COUNCIL ASSESSMENT REPORT

Panel Reference	PPSSCC-122
DA Number	DA 1262/2019/JP/A
LGA	The Hills Shire Council
Proposed Development	Section 4.55 (2) Modification to an Approved Concept Development Application for Five Residential Buildings Comprising 228 Apartments, Two Levels of Basement Parking and Landscaping
Street Address	7-23 Cadman Cres and 18-24 Hughes Ave Castle Hill
Applicant	Castle Hill Panorama
Consultant/s	Mecone (Planner) InRoads: Group (Traffic Report) MHN Design Union (Architects) GMU (Urban Design Peer Review) RICQS (Quantity Surveyors) SurvPlan (Building Survey) TurfDesign Studio (Landscape Architects)
Date of DA lodgement	23 July 2020
Number of Submissions	One
Recommendation	Refusal
Regional Development Criteria (Clause 123BA Instruction on Functions exercisable by council on behalf of regional panel under The EP&A Regulation 2000)	Section 4.55(2) to a Regional Development Application previously approved by the regional panel and subject to proposed amendments to a condition of development consent (condition 3) recommended in the council assessment report but which was amended by the panel.

Report date	October 2021 (Electronic Determination)
--------------------

Figure 1: Additions (highlighted in red) proposed to originally approved Concept DA.

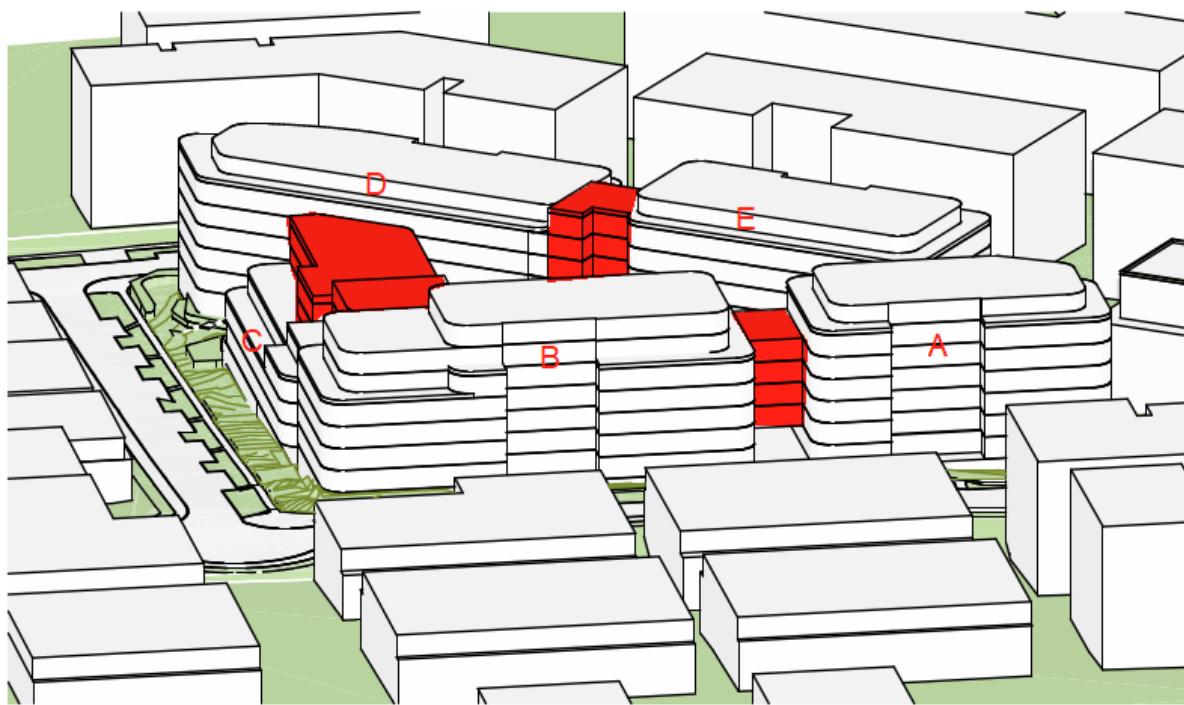
The quantitative changes to the building envelopes from the proposed modification application will result in an intensification of the approved parameters for bulk and scale of the concept application when viewed from the Cadman Crescent (north) and Hughes Avenue frontages. The addition of “apartment connectors” between the buildings result in an exceedance to the maximum 65m building length control under the DCP. This results in the potential for future built form that will be overwhelming in bulk and scale and do not allow for view corridors between building towers. Refer to Section 6 for further discussion regarding the non-compliance. Notwithstanding the “apartment connectors”, the building separation between the northern buildings (Building A and B) has been reduced from 10m to 7.6m and will result in the provision of less solar access to the central communal open space area. It is noted that the Design Review Panel attributed the success of the original concept application to the high level of amenity provided to the central communal open space area. The DRP notes that *“the central communal open space is pivotal to the success of the originally approved concept application and the proposed bridging elements reduces visual connectivity into and out of the courtyard space”*.

generated by the additional yield, height and “apartment connectors” change essential elements and the “essence” of the development such that it is not considered to be substantially the same.

The proposed modified Concept Development Application differs, both quantitatively and qualitatively, from the original approved development. These differences result in the proposed modified development not being substantially the same as the originally approved development and therefore is not supported pursuant to Section 4.55 of the Environmental Planning and Assessment Act, 1979.

Figure 2: Proposed Building Lengths, Separation and Setbacks

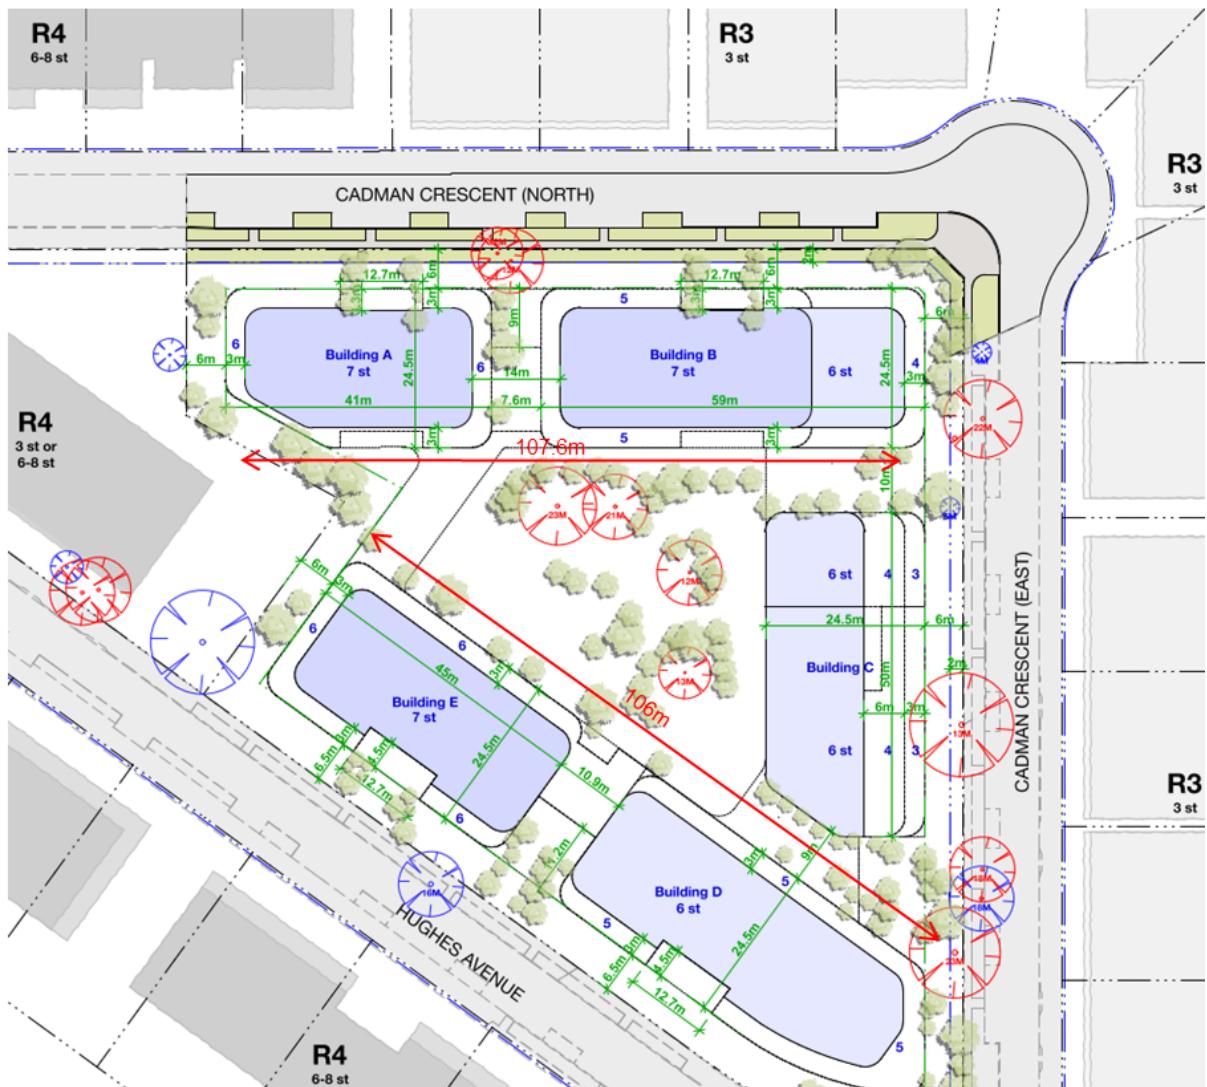
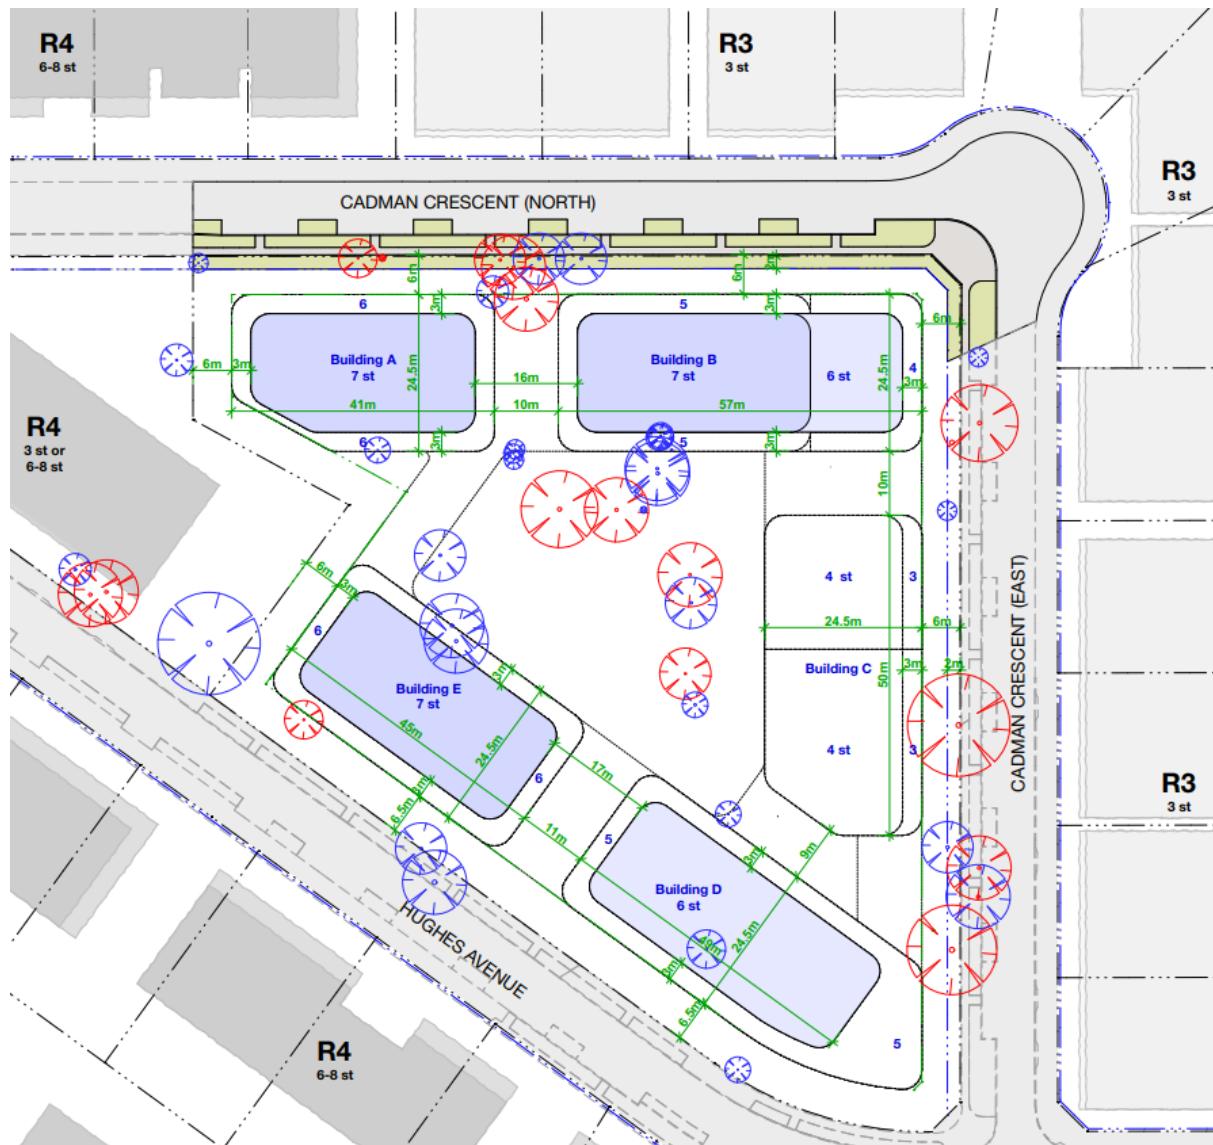
The DCP requires that buildings are to have a maximum length of 65m. Where a building has a length greater than 30m it is to be separated into at least two parts by a significant recess or projection. The proposed modification includes “apartment connectors” between Buildings A/B and D/E resulting in maximum building lengths of 107.6m and 106m respectively.

It is acknowledged that the proposed modifications relate to a concept development application with indicative building envelopes and no built form is proposed as part of the application. It is noted that whilst the original application did not comply with the maximum 40m façade lengths required under the DCP, however the application was approved with the following compliant maximum building lengths:

The variation to façade lengths was supported as it was envisaged that subsequent built form Development Applications would include significant recesses and projections detailing sufficient articulation to break up the building mass.

Whilst it is acknowledged that the Applicant has indicated that these “apartment connectors” could be deleted at the second Design Review Panel meeting, amended plans were not lodged with the subject application. In this regard, the proposal has not been amended to

The proposed modification does not meet the intent of the control and the variation to the front setbacks is not supported.
